**METROPOLITAN DEVELOPMENT COMMISSION
HEARING EXAMINER**

Case Number: 2025-CZN-844 / 2025-CVR-844

Property Address: 127 East 34th Street (approximate address)

Request: Rezoning of 0.11-acre from the C-1 (TOD) district to the D-5 (TOD) district to provide for a multi-unit house consisting of four units.

SITE PLAN

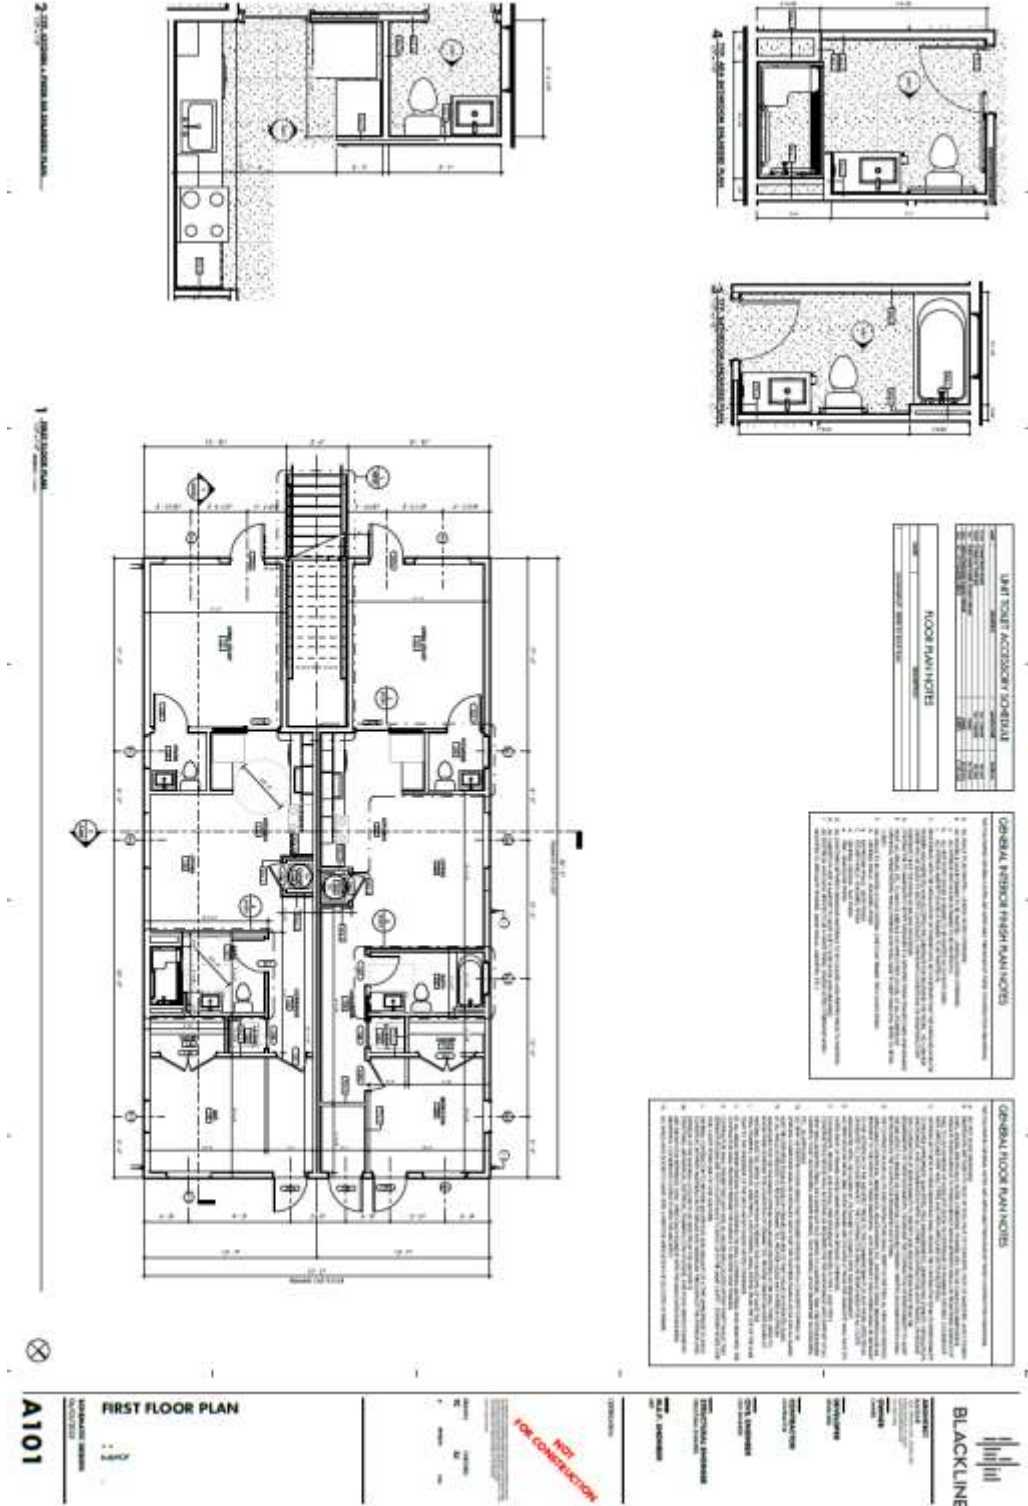
The grant of the Variance of Development Standards would permit a zero-foot east side yard setback for a surface parking area where a minimum three-foot side yard setback is required.

Lastly, the petitioner was made aware that per TABLE 744-701-2: PRIVATE FRONTAGE DESIGN STANDARDS, any front entry feature cannot extend further than five feet into the 10-foot required front yard setback. The final site plan will need to be adjusted to meet this standard unless a variance is sought at a later time.

FIRST FLOOR PLAN

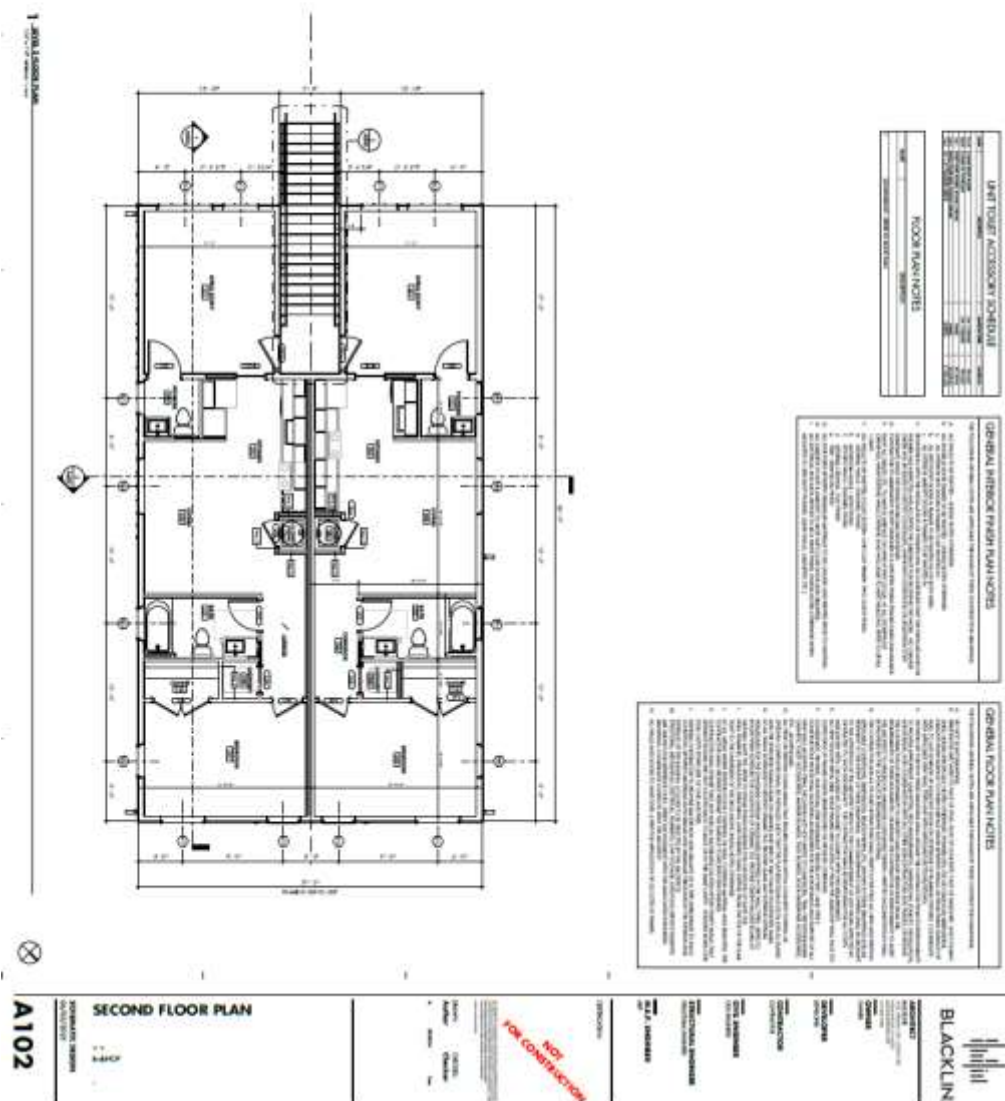
However, the floor plans and elevation that were submitted at staff's request resulted in the discovery that the proposed building type would not be a multi-unit building as defined by staff. Instead, each individual unit would have its own exterior entrance and would therefore be classified as a small apartment.

Staff informed the petitioner of this discrepancy and recommended they amend the request to rezone the site to the D-8 district for a small apartment, which staff would support.
